ECE/TRANS/WP.29/2009/36
17 December 2008

Proposal for Supplement 12 to Regulation No. 43
(Safety Glazing)

Submitted by the Working Party on General Safety Provisions */

"Laminated glass panels other than windscreens

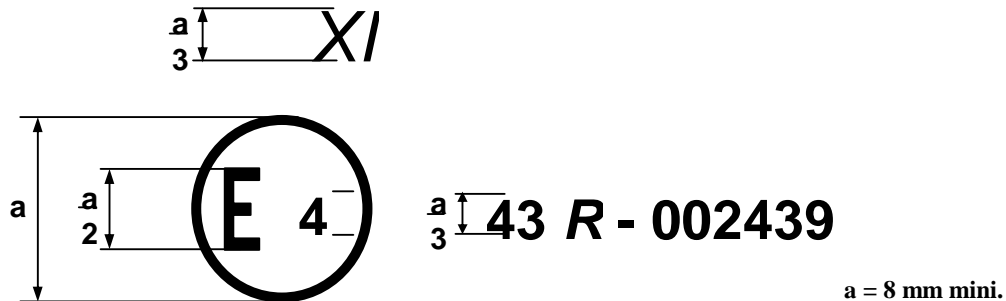
Add the following approval mark examples, to read:

The above approval mark affixed to a laminated glass pane other than a windscreen, shows that the component concerned has been approved in the Netherlands (E 4) pursuant to Regulation No. 43

under approval No. 002439. The approval number indicates that the approval was granted in accordance with the requirements of Regulation No. 43."
